Unconfirmed Meeting Minutes: Meeting of the IEEE P802.3cg 10 Mbps Single-Pair
Ethernet Task Force

Sept 12-14, 2018
Spokane, WA USA

Prepared by Jon Lewis, Dell EMC and Curtis Donahue, UNH-IOL

Figure 1–1—IEEE 802.3 standard relationship to the ISO/IEC Open Systems Interconnection (OSI) reference model

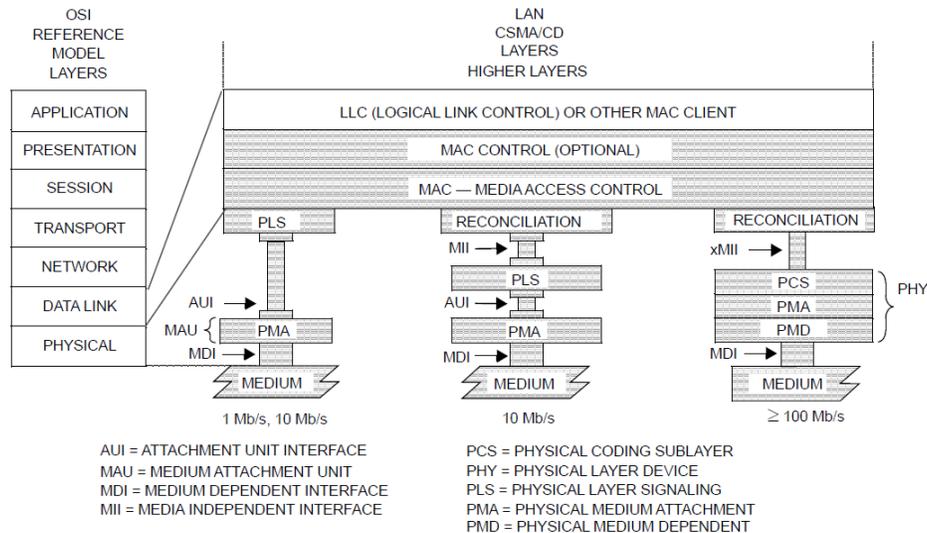
Motion #8: Move to disposition comment #304 as “Accept in Principle” with the following modifications to the draft.

In Clause 1.1.3 Architectural perspectives, update “Figure 1–1—IEEE 802.3 standard relationship to the ISO/IEC Open Systems Interconnection (OSI) reference model (shown below).

Change “100 Mb/s” at the bottom of the right column to “100 Mb/s, 10BASE-T1L, 10BASE-T1S”
